TECHNICAL SERVICE BULLETIN

SUBJECT: TRANSMISSION GEAR DISENGAGEMENT -
CORVAIR "95" AND GREENBRIER MODELS

BULLETIN NO. DR # 480

DATE May 18, 1961

FIGURE 1

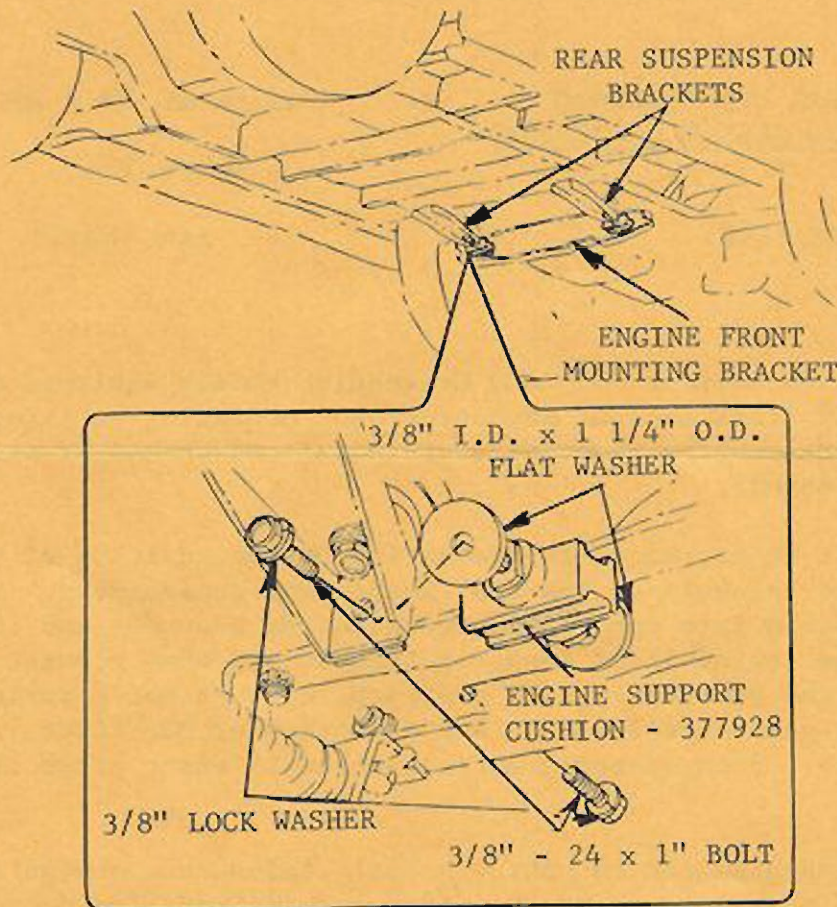
On 4-speed transmission models, install an engine support cushion 377928 with a 3/8" I.D. x 1 1/4" O.D. flat washer at each end between the rear suspension crossmember supports and engine front mounting bracket (Fig. 1). Secure the cushion with a 3/8" - 24 x 1" bolt and 3/8" lockwasher at each end tightened to approximately 20 ft.-lbs.

On 3-speed jobs, the same procedure applies except it will be necessary to add sufficient additional 3/8" flat washers between the ends of the cushion to completely fill the area between the support bracket and engine front mount. Extra washers should be added equally at each end of cushion. It is essential that the space be completely filled in order to effectively eliminate any forward movement of the powertrain.
